TENNESSEE VALLEY AUTHORITY
River System Operations & Environment
River Operations

Hydrothermal Modeling of Browns Ferry Nuclear Plant With Units 1, 2, and 3 at Extended Power Uprate

WR2005-1-67-135

Prepared by
Paul N. Hopping
and
Walter L. Harper

Figure 11. Computed and Measured River Temperature Upstream of BFN for 1993

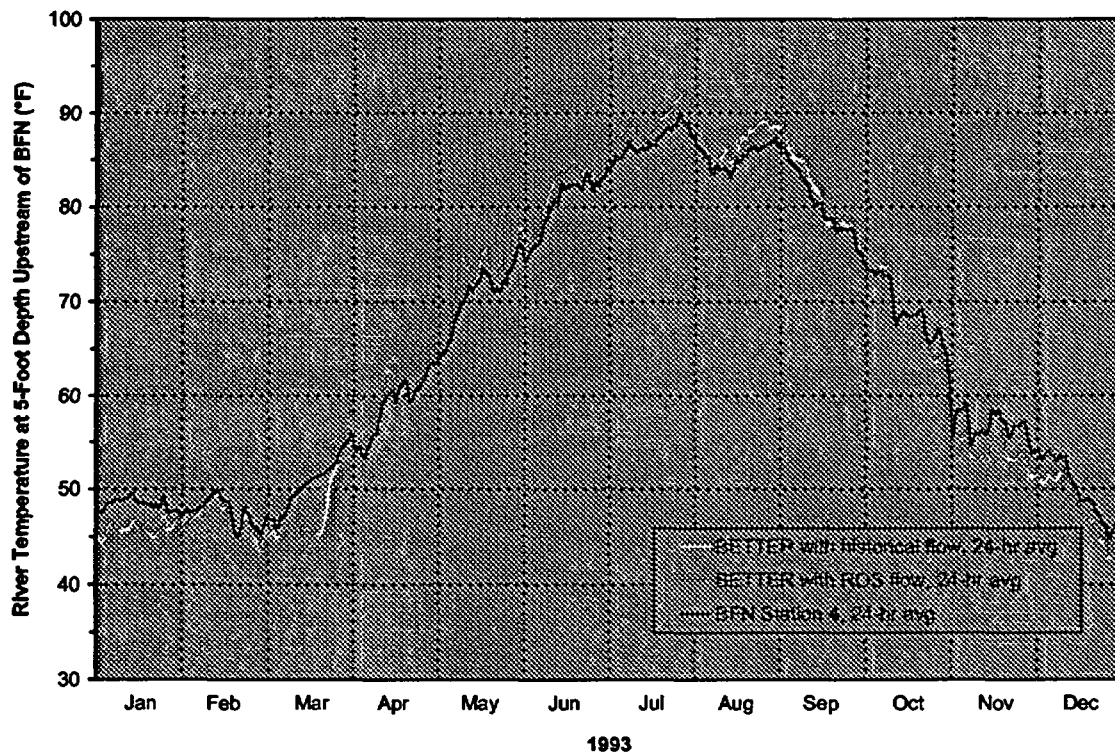
IL3.2 The response to Question 11, regarding Figure 11 and the effects of ROS releases on upstream river temperatures at the hourly scale, should be included in the report.

Figure 16. Temperature Rise across BFN Condensers

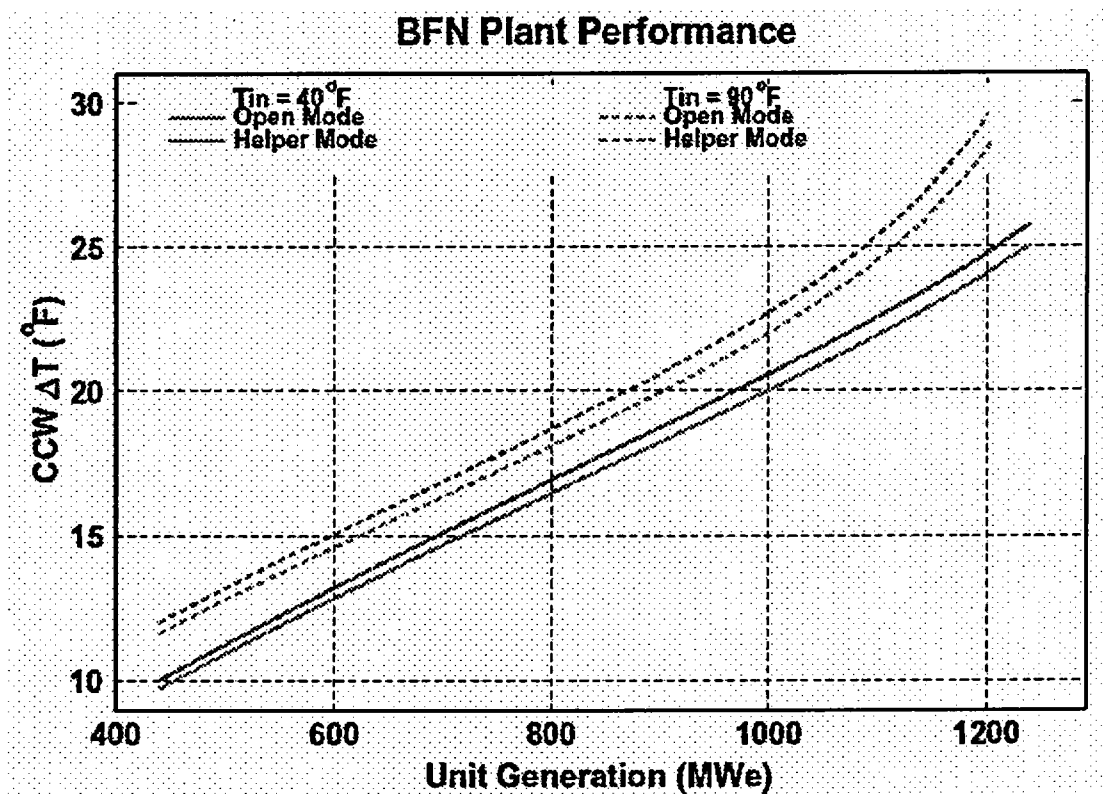
16. Page 30, Figure 16. Does the higher CCW ΔT for helper mode simply reflect the reduced CCW flowrate, or am I missing something else?

The reduction in CCW flow is due to the increased losses associated with passing the water through the conduits to the cooling tower warm water channel (e.g., see Figure 5 and Figure 6). This brings to the attention another feature of the model that needs to be better emphasized in the report—that is, the hydrothermal model does not determine the detailed hydraulic characteristics of the flow throughout the CCW conduits and channels (e.g., HGL and EGL).

Figure 23. Computed vs. Measured Temperatures for Two-Unit Operation for Summer 2002

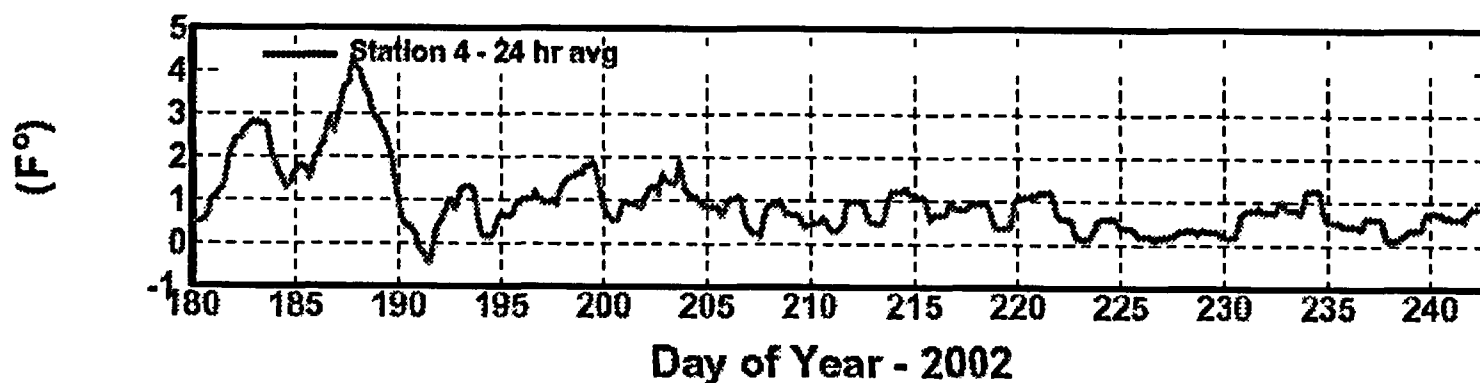
II.1.3 The rather poor agreement between the measured and computed downstream temperatures from days 206 to 218 in 2002, Figure 23, should be commented on in the text. Something else must have been going on.

Figure 25. Baseline (Case 0) Results for BFN Simulations

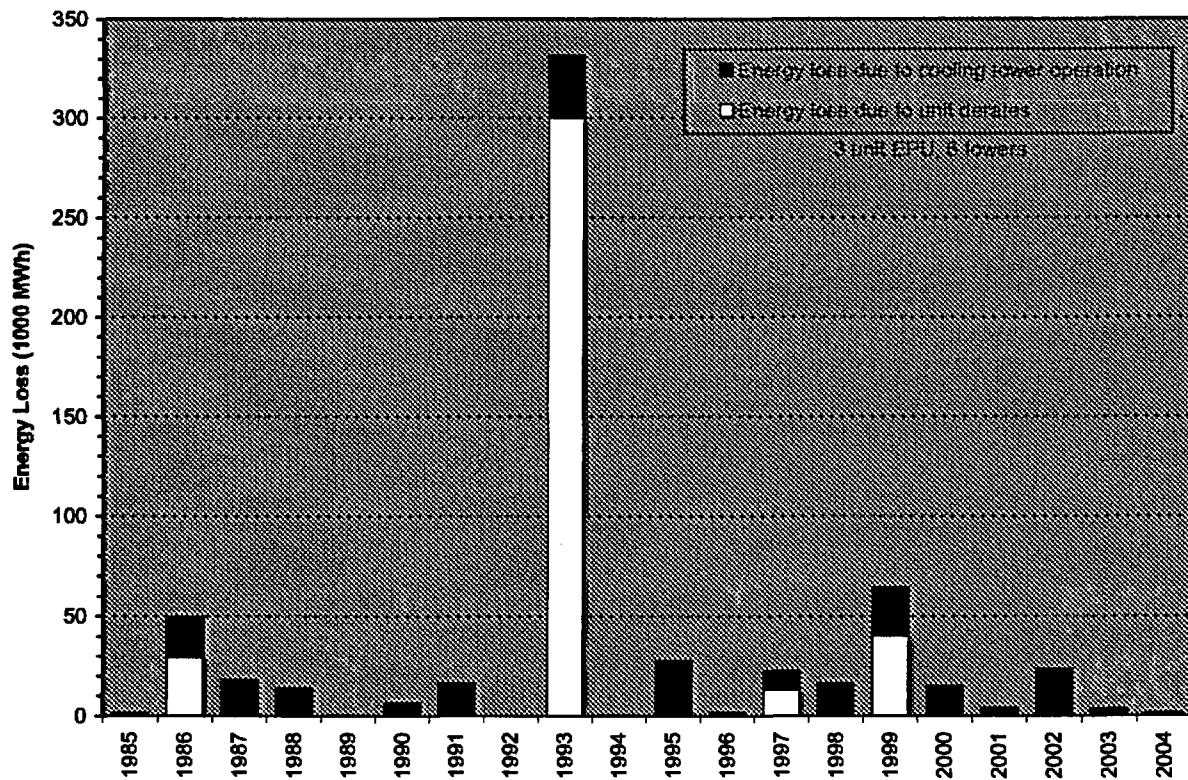
II.7.1 The Case 0 results as depicted in Figure 25 are not consistent with Table 9 from which they were drawn. However these same results as depicted in Figures 31, 32, and 33 appear to be correct.

Figure 26. BFN Operation for 1993

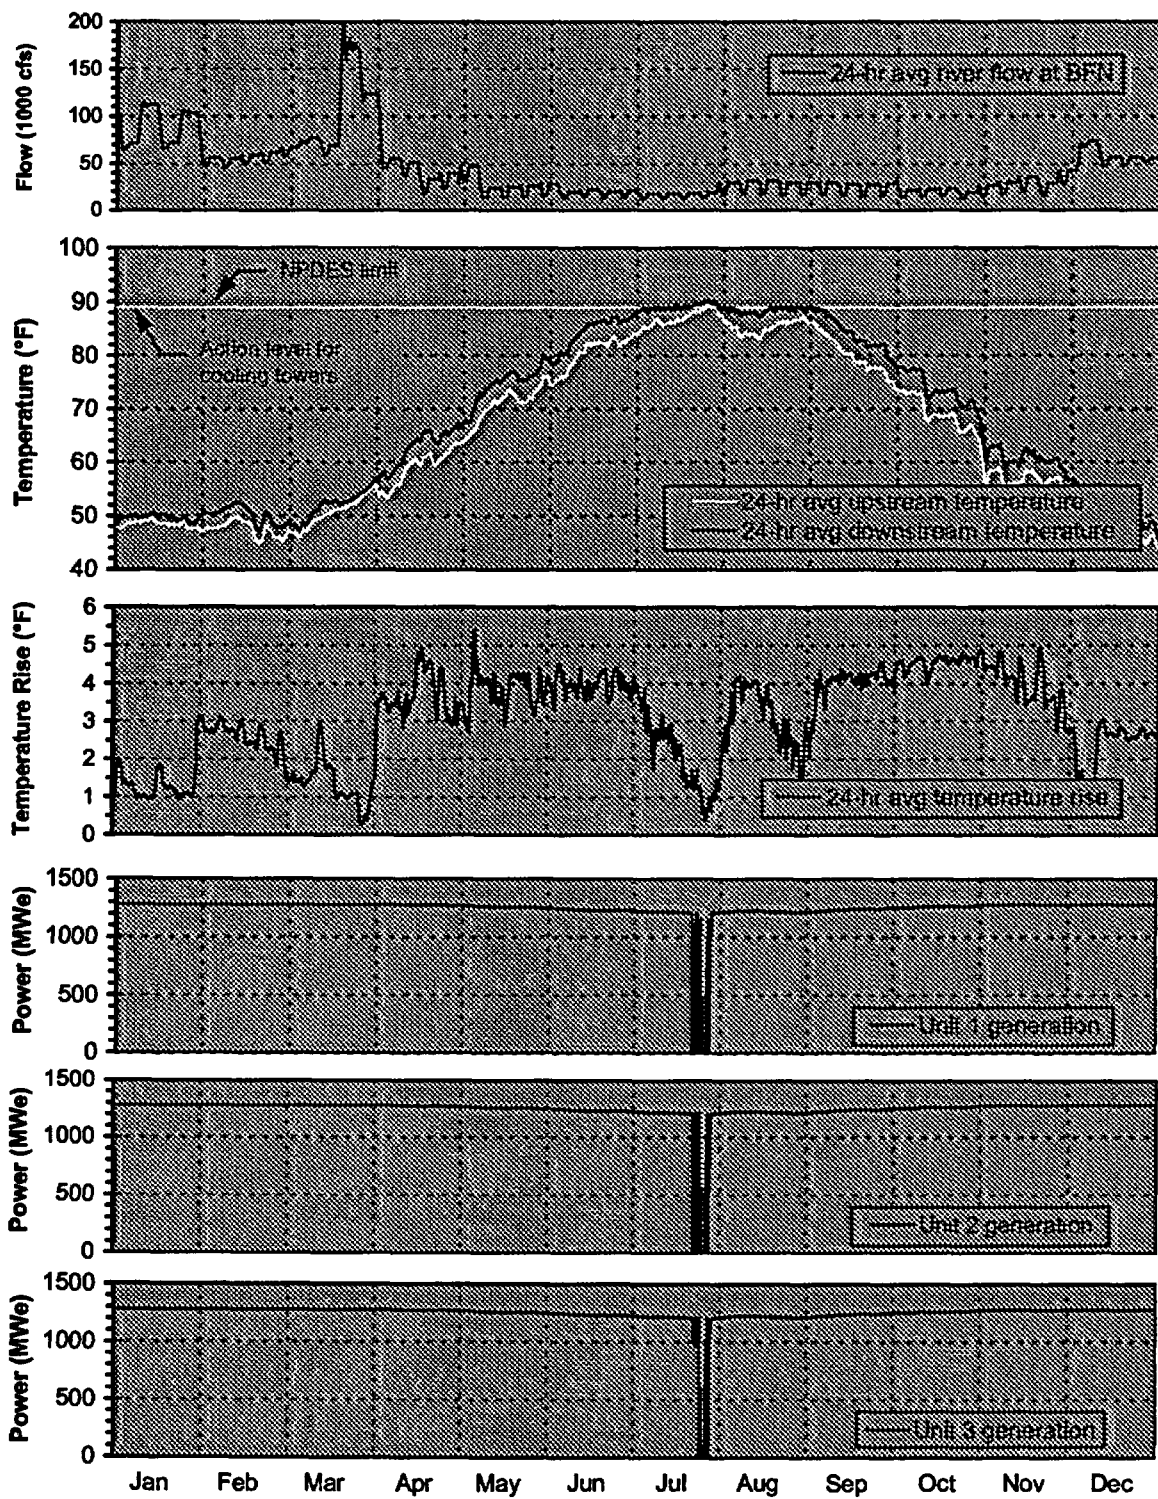
II.7.2 In Figures 26 and 27, one can infer when towers were in operation by the changes in the temperature rise. Nonetheless, it would be interesting to show tower operation directly, as the text refers to the timing of tower operation as well as unit derates. This would add one panel to the Figures, but it would make the Figures even more complete and informative.

Figure 27. BFN Operation for Late July 1993

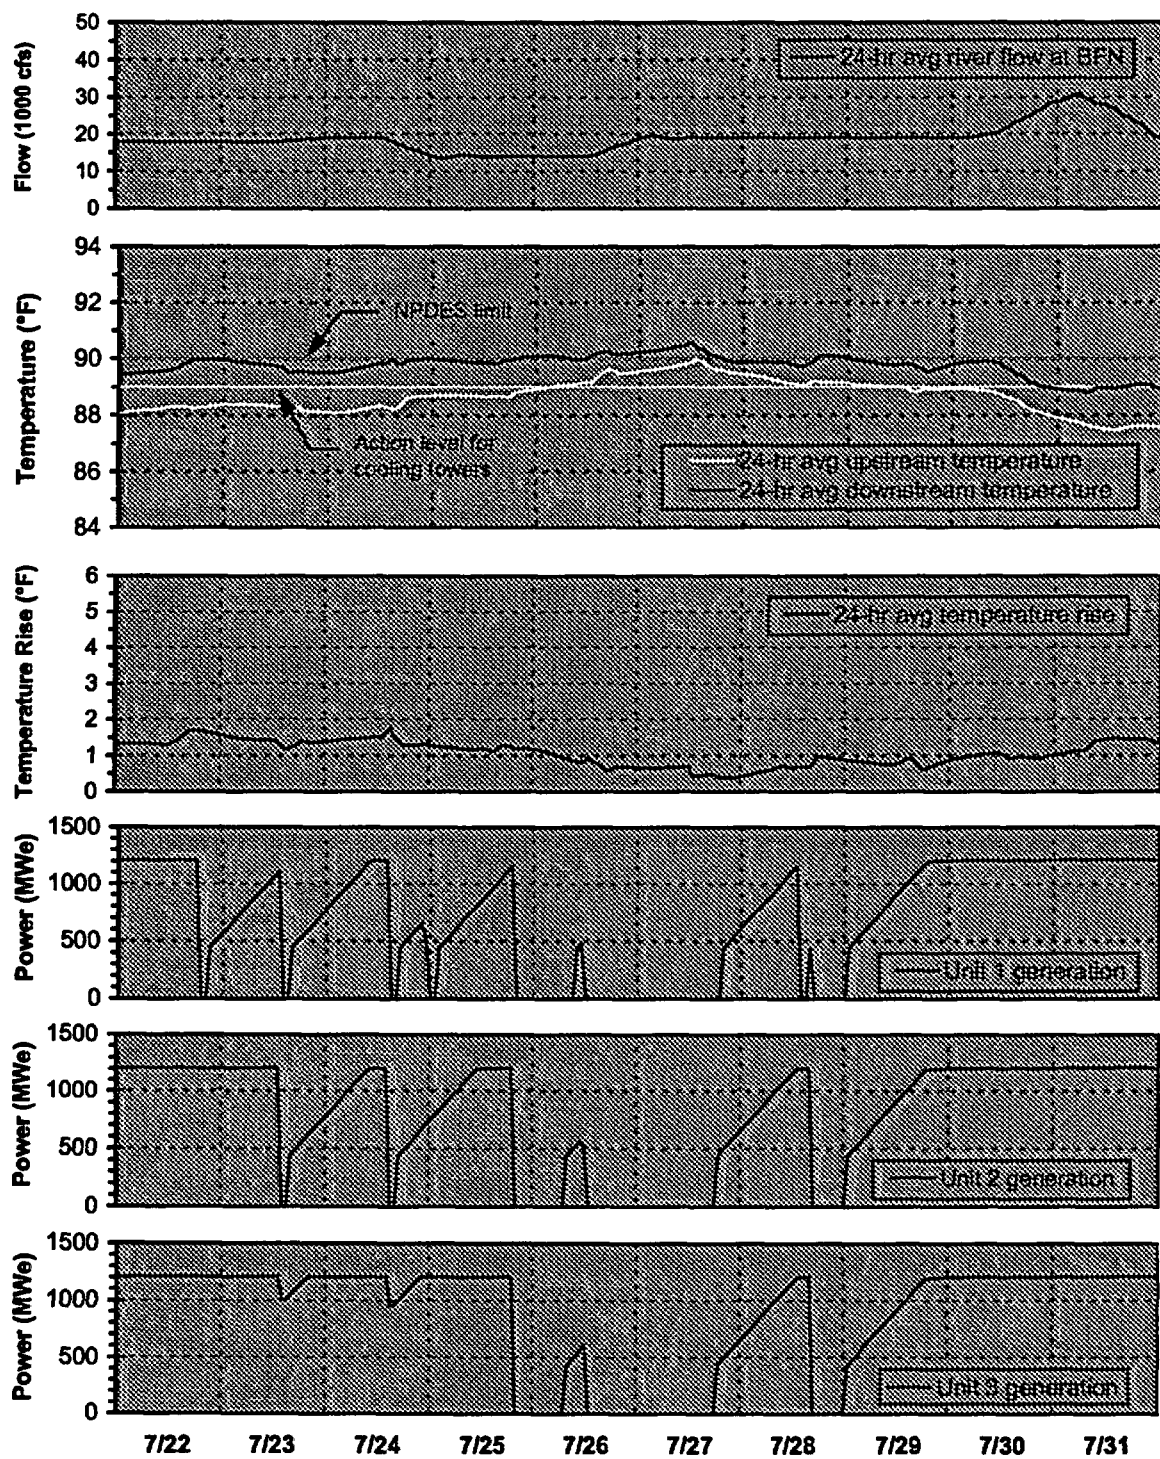
II.1.5 Figure 27 seems to suggest that the model predicted an apparent NPDES permit violation on 26-27 July of 1993 – yet in the model the units were shut down. There is

Figure 29. Effect of Condenser Cleanliness Factor on Condenser Temperature Rise

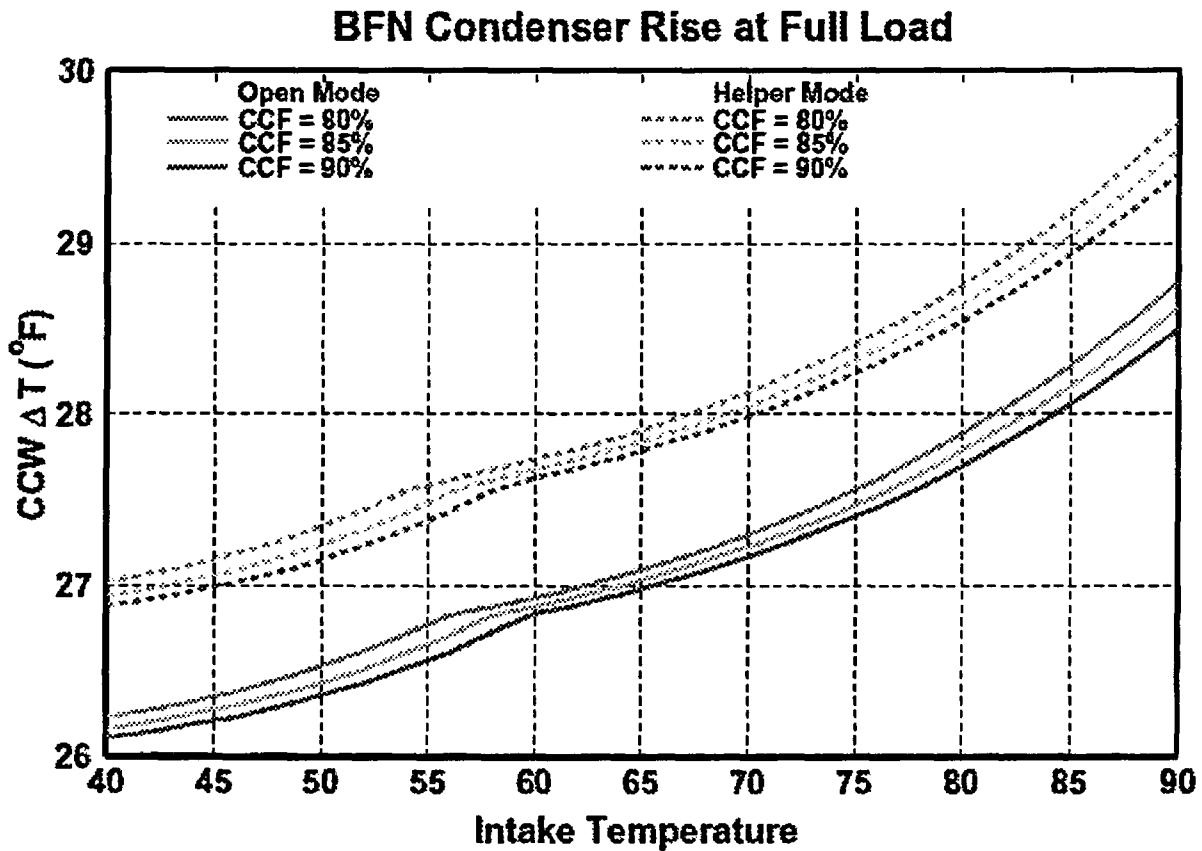
IL3.1 Figure 29 has some strange kinks in the condenser curves that do not appear to be reflected in Figure 16. These are not the same presentation, but it would be helpful if the authors could explain the anomalies in the curves, if in fact they are anomalies.
